Jackson: Audio "Distortion/Blaring"
by R.M.

See partial schematic below of components to be changed: (*)

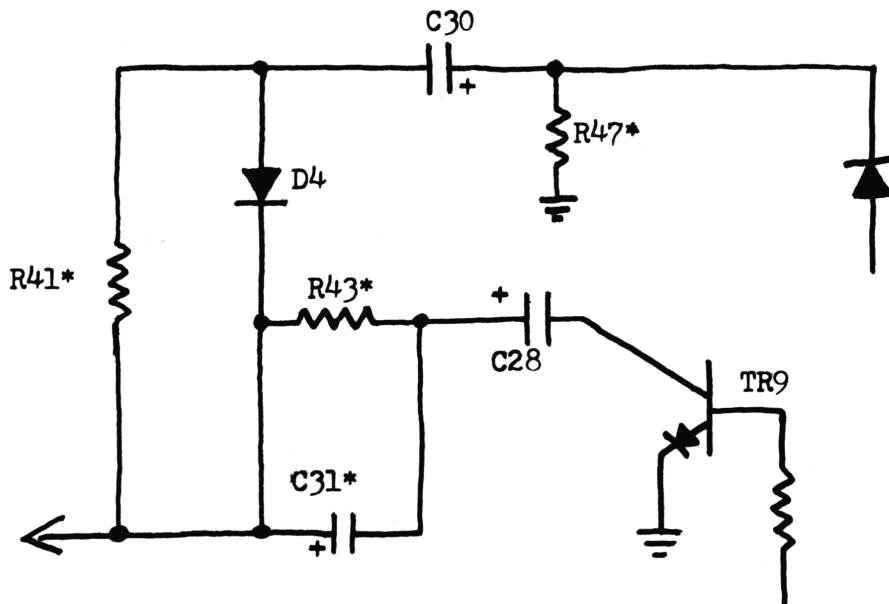
At close range the Jackson has the problem of receive SSB audio being distorted, the RF Gain has very little control over this.

1. Remove C-31 (0.47Mfd/50VDC electrolytic), no replacement.
2. R-43 (10K); change to 1.5K.
3. R-41 (150K); change to 270K.
4. R-47 (1.5K); change to 3.9K.
